**BEFORE THE COMMISSION  
APPOINTED BY THE OTAGO REGIONAL COUNCIL**

**IN THE MATTER** Of an application by Dunedin  
City Council for resource  
consent being processed with  
reference RM20.280

**STATEMENT OF EVIDENCE OF DAVID IFE**

**DATED 6 MAY 2022**

Figure 1 Smooth Hill Landfill – Proposed layout (from Dunedin City Council, 2021)

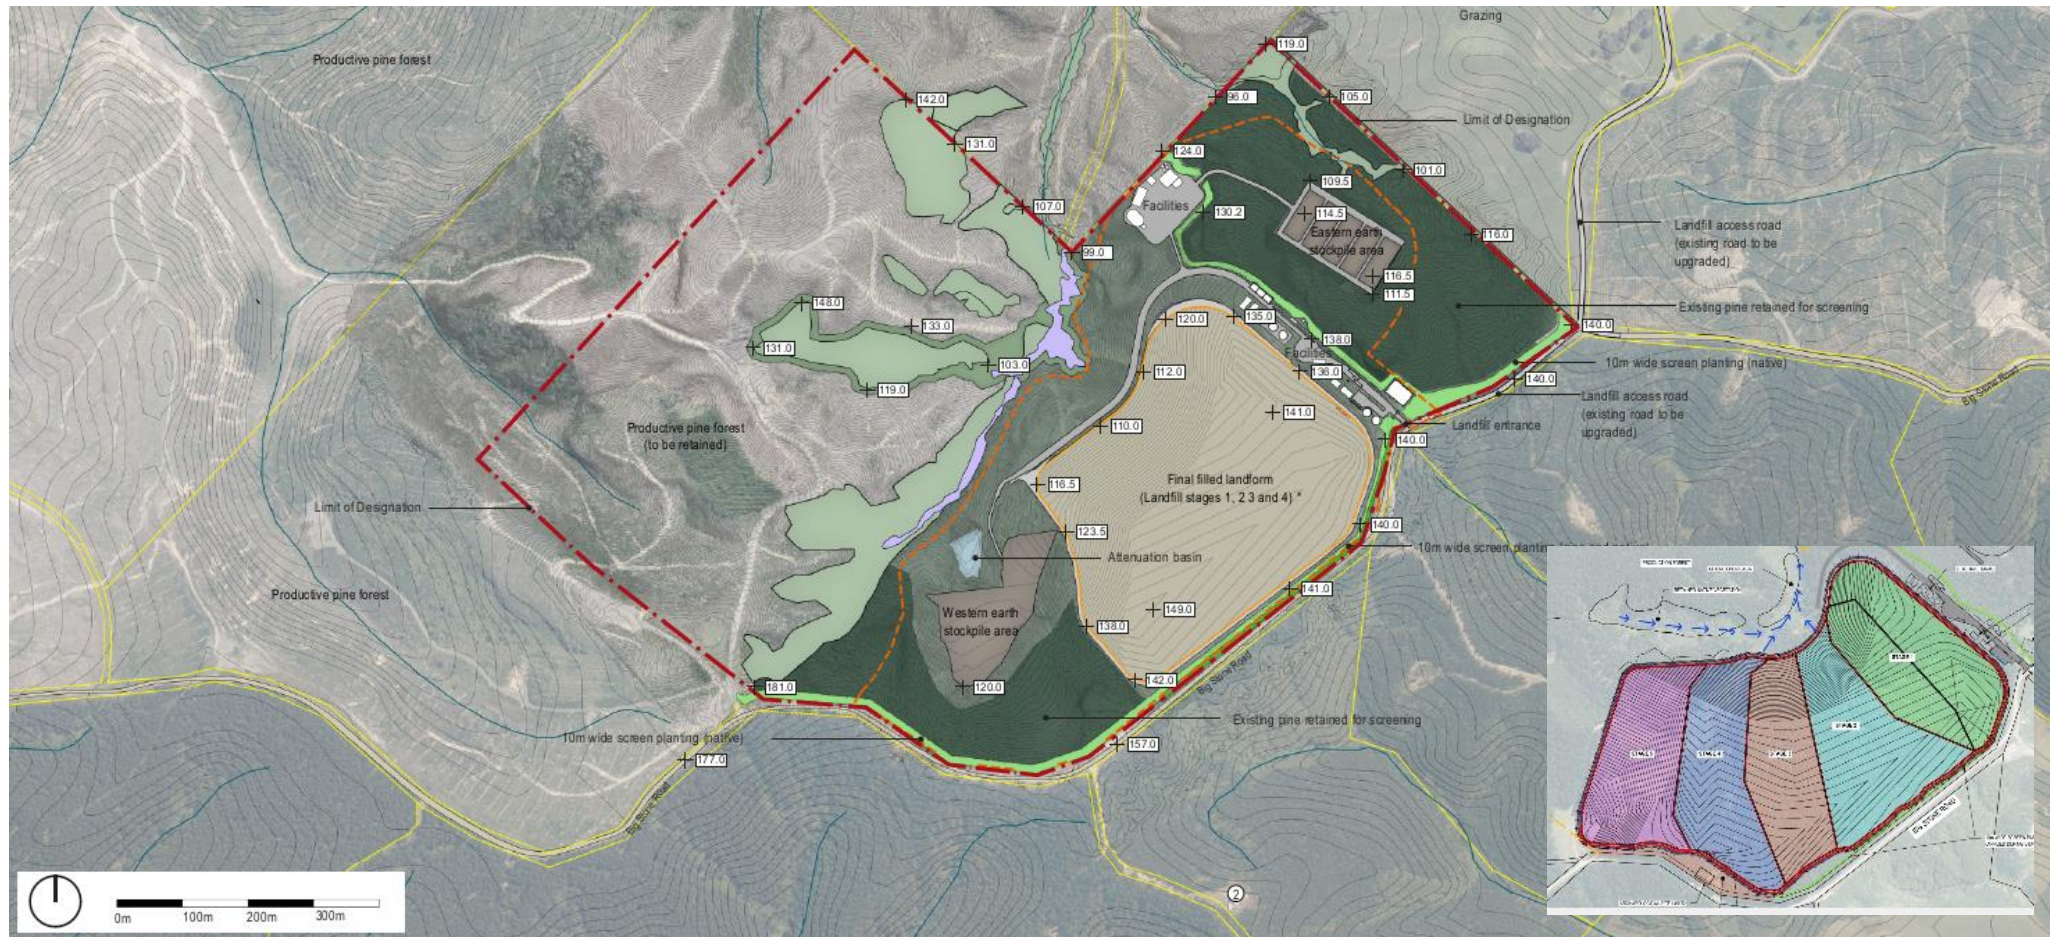
- landfill gas management; and
  - a rigorous monitoring and reporting regime
18. The proposed layout of the landfill is shown in **Figure 1**.
19. The landfill will receive 60,000 tonnes/year over the 40 year life of the facility and its footprint at closure will be 18.6 ha with a total capacity of 3.3 Mm<sup>3</sup> (gross) and 2.96 Mm<sup>3</sup> (net).

44. The landfill site is located in an area of significant topography – with slopes between 4% and 25% and the proposed landfill is essentially a valley fill.

45. According to BPEM valley fill landfills are to be avoided as they “have inherent environmental problems such as unstable slopes, water infiltration and leachate seepage.”

46. Valley fill landfills are more prone to issues of contamination arising as a result of high stormwater flows causing runoff to breach diversion drains, flow into the active cell and merge with leachate.

Figure 2 Bore locations (after GHD, 2021)

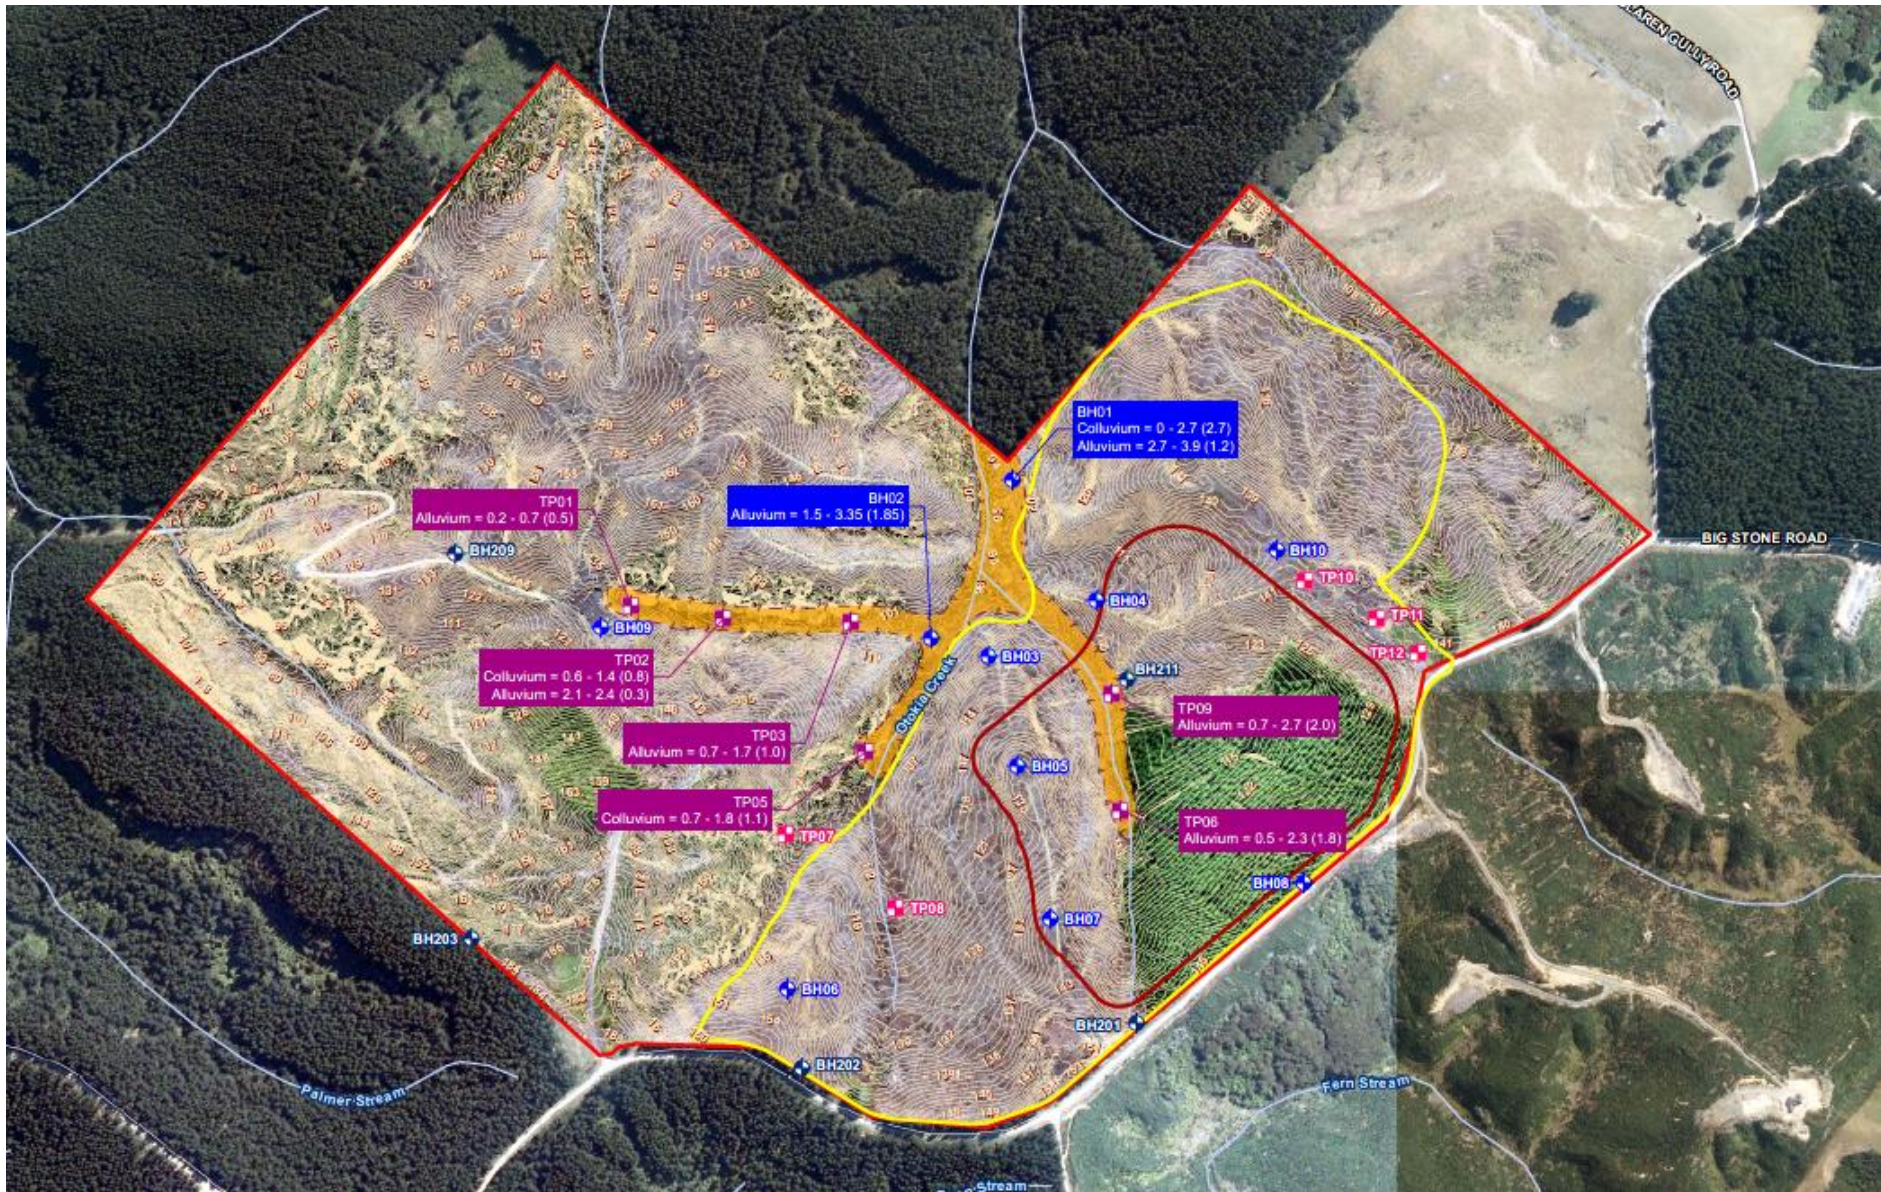
24. Two phases of intrusive site investigation were undertaken in 2019, with ten boreholes and eleven test pits advanced between May and June, and an additional five boreholes and 15 bulk samples collected from a number of shallow test pits between October and November 2019.
25. Bore locations are shown in **Figure 2**.

27. In the alluvium/colluvium where the landfill is to be mainly developed, groundwater levels appear to be very close to surface (refer Figures 7 and 8 in Groundwater Report - Appendix 8).

28. Water table levels are within 2m of surface in bores BH01A, BH01B, BH02A and BH02B.
29. The Statement of Evidence of Anthony Kirk states that the deep groundwater system in the Henley Breccia does not provide baseflow to any streams and that it discharges directly to the ocean whereas the shallow groundwater system is linked to surface water in the Ōtokia Creek catchment. However, his cross section C (Figure 2 of his evidence) shows that groundwater levels in the deep and shallow bores at BH01 are similar, suggesting a degree of hydraulic connectivity between the two aquifer systems at the creek level.

53. The site is underlain by high quality groundwater and at the lower slopes of the cells the water table is close to the bases of the landfill, requiring a groundwater underdrain to be incorporated into the design.
